CITY OF FRANKLIN PLAN COMMISSION MEETING* FRANKLIN CITY HALL COUNCIL CHAMBERS 9229 W. LOOMIS ROAD, FRANKLIN, WISCONSIN AGENDA THURSDAY, APRIL 8, 2021, 7:00 P.M.

REPORT TO THE PLAN COMMISSION

Property Owner/Applicant:	Wendt Family Trust/WP Property Acquisitions LLC	
Property Address/Tax Key Number:	3617 W. Oakwood Road/950-9997-002	
Aldermanic District:	District 4	
Agent:	Mark Lake, Wangard Partners, Inc.	
	Michael Froehlich, P.E., Kapur Engineering	
Zoning District:	PDD 39 (Mixed Use Business Park)	
Use of Surrounding Properties:	Residential and vacant zoned PDD 39 (east and south), County parklands zoned P-1 (west and north)	
Action Requested:	Recommendation to the Plan Commission and Common Council for approval of the proposed Natural Resource Special Exception (NRSE)	
Staff Planner:	Marion Ecks, Associate Planner

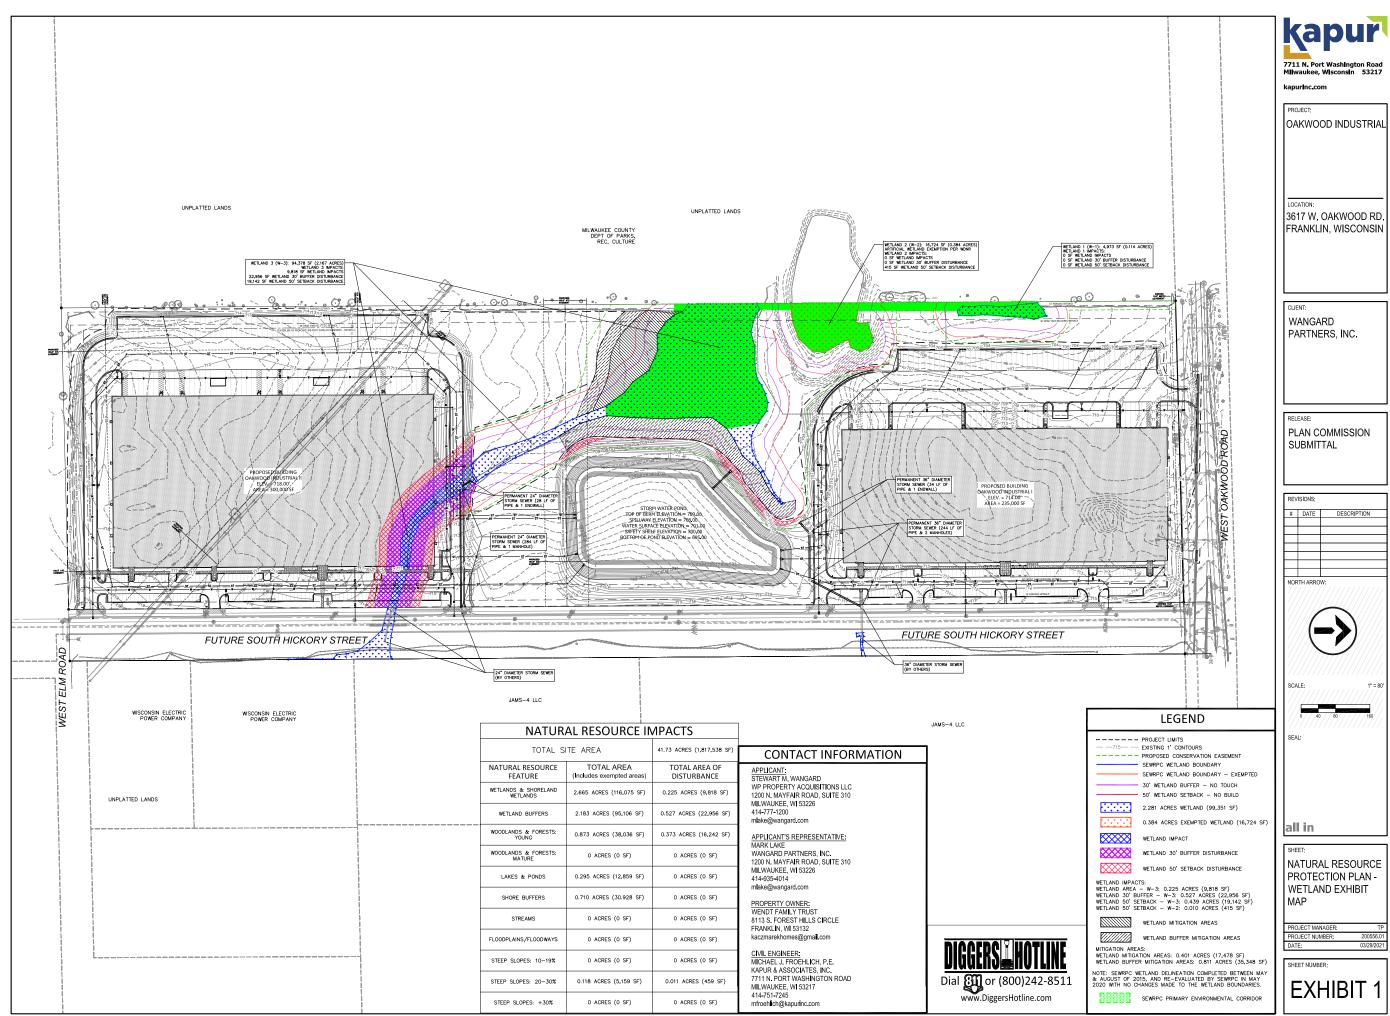
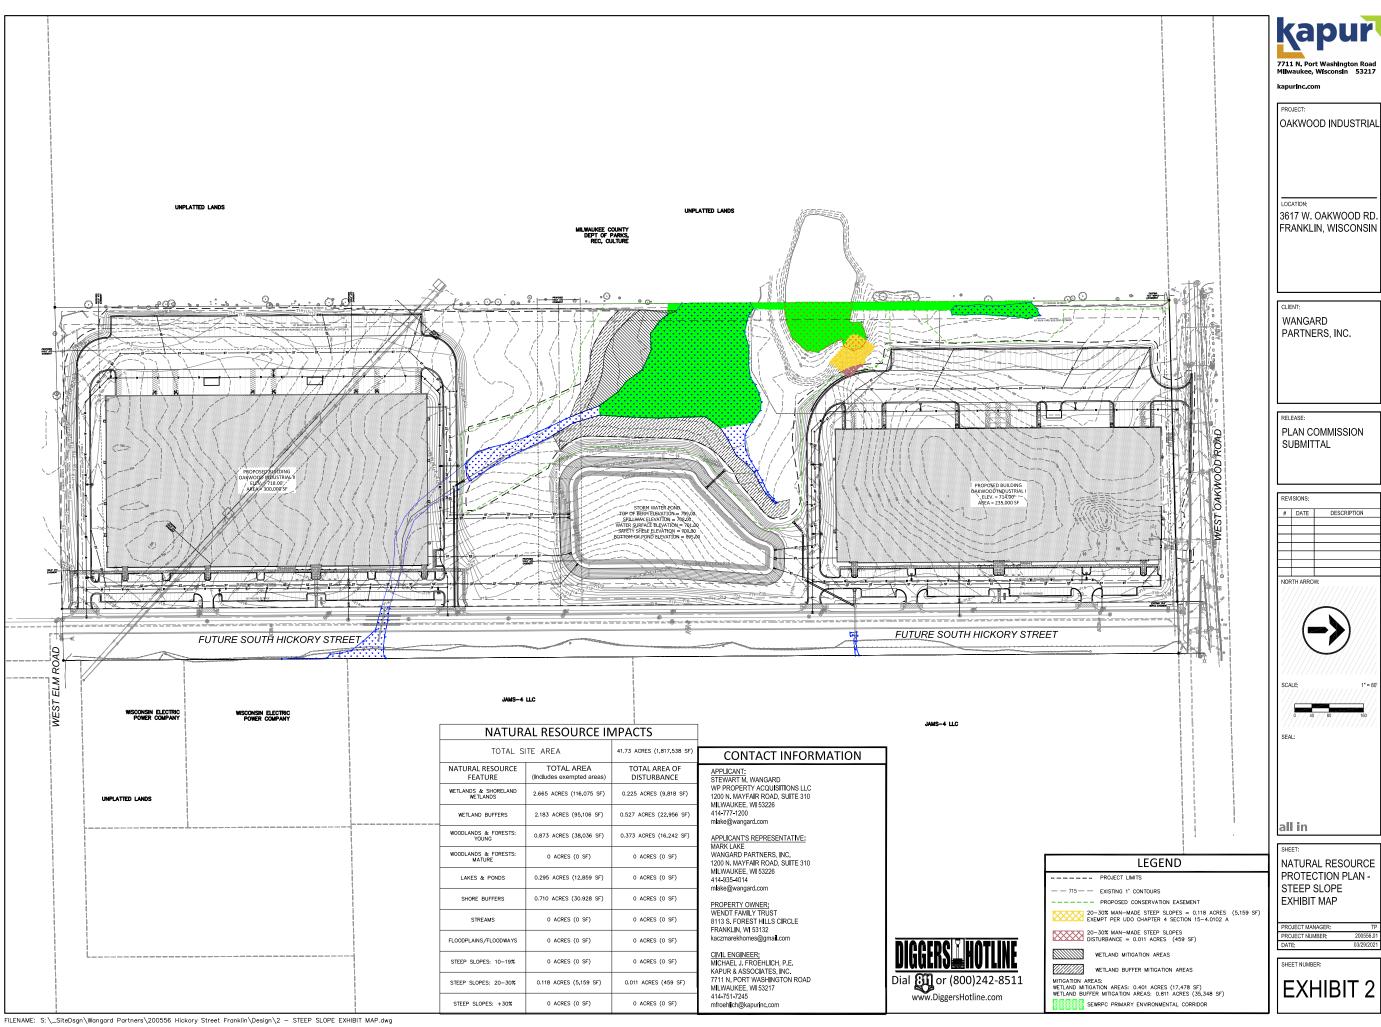
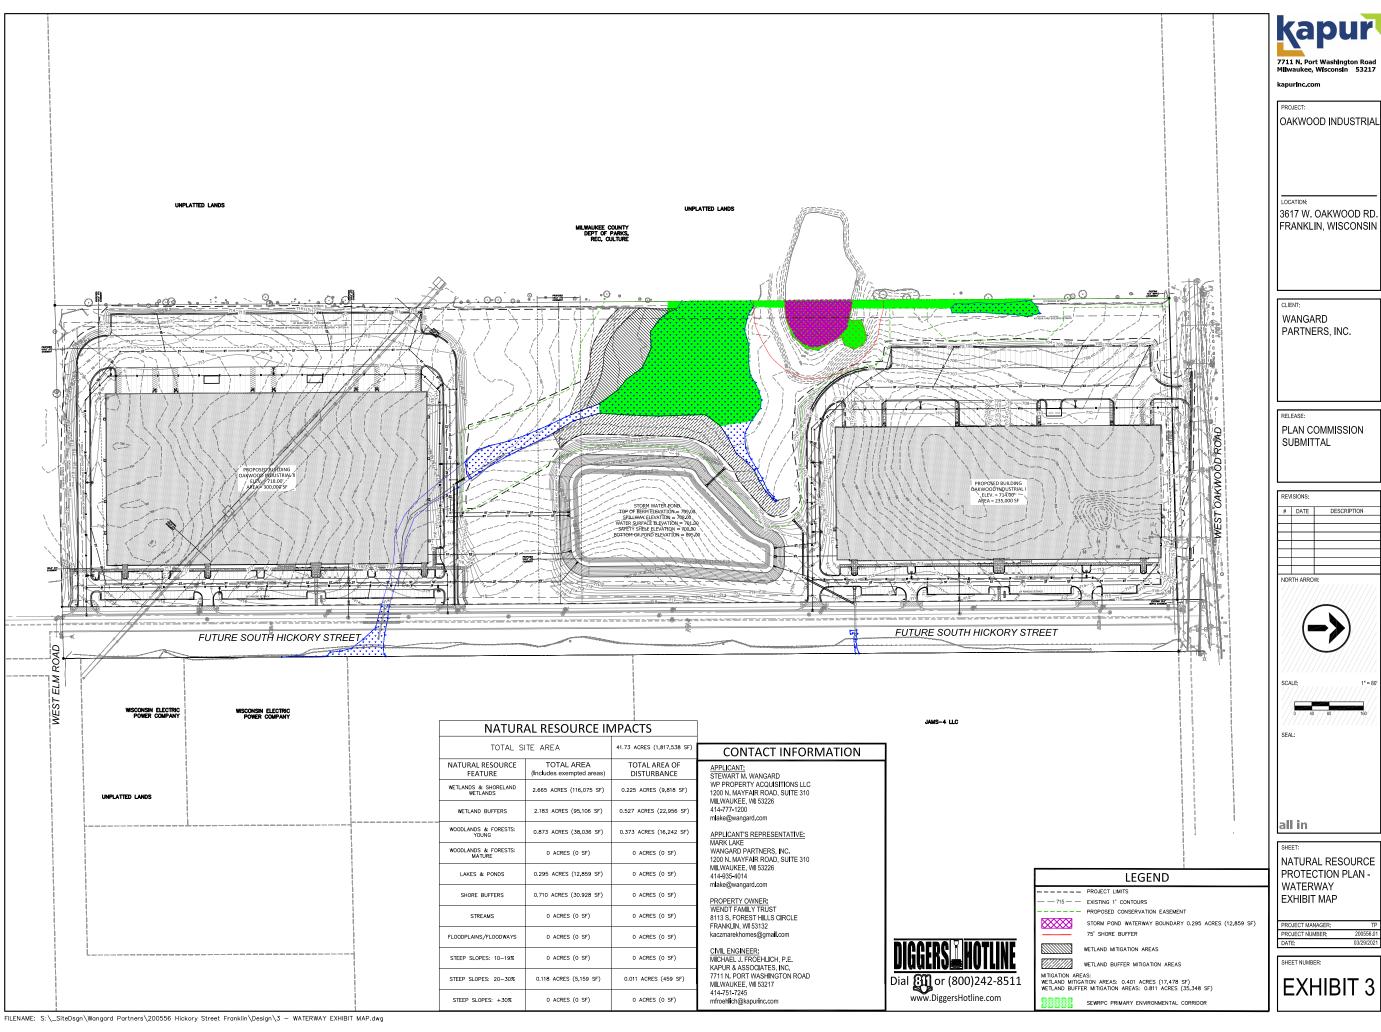
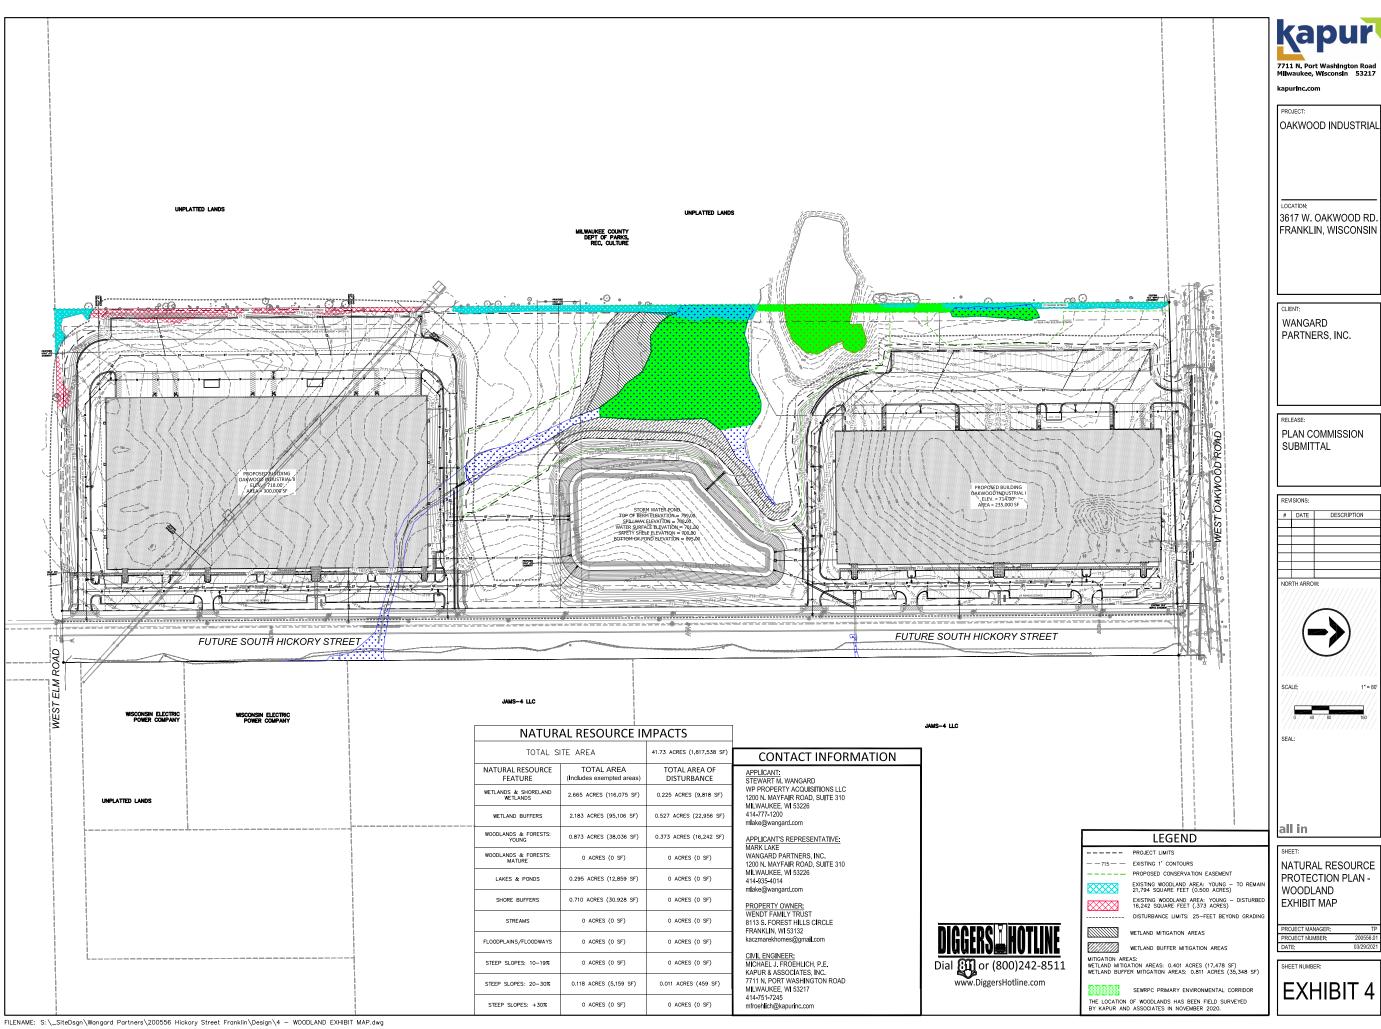
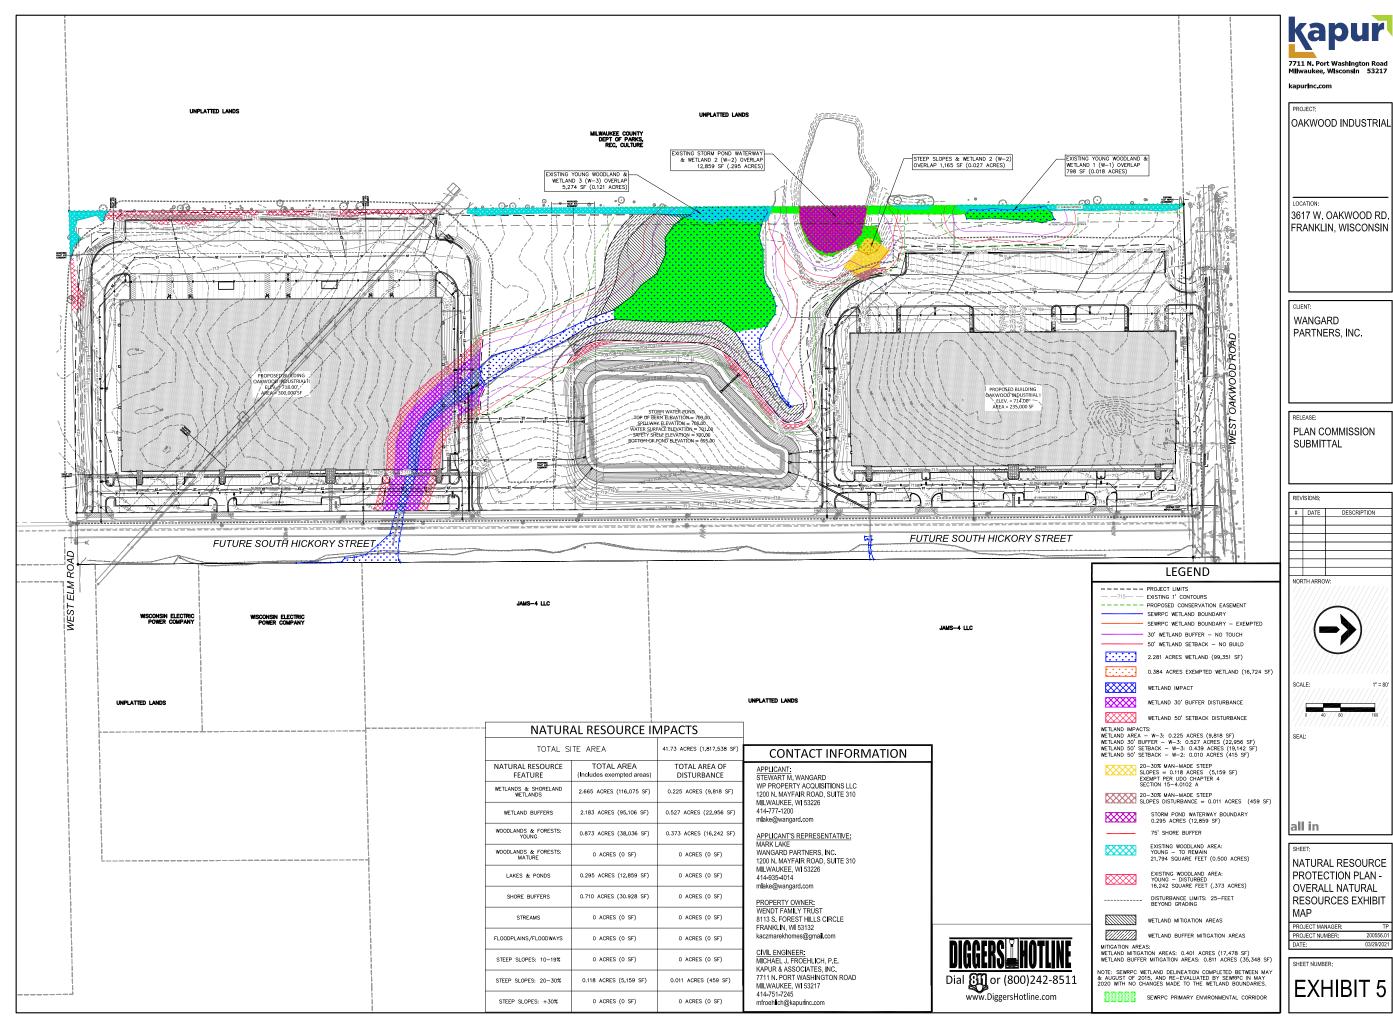
3. Please provide contact information including address and telephone number for the owners and developer on the NRPP as required by §15-7.0201.C. Staff suggests this information be included on the NRPP exhibit maps.

7. Please verify that all easements on (immediately adjacent to) the property line are depicted on the NRPP map (§15-7.0201.H).

10. Please provide Site Intensity calculations in the NRPP report (§15-7.0201.N). Note that LSR standard for the Business Park portion of PDD 39 is 0.25.

Kapur: Contact information for owners and engineers has been added to each NRPP exhibit map.

Kapur: All easements have been added to the NRPP exhibit maps.

Kapur: The site intensity calculations have been added to the NRPP report and the LSR has been updated from 0.45 to 0.25.
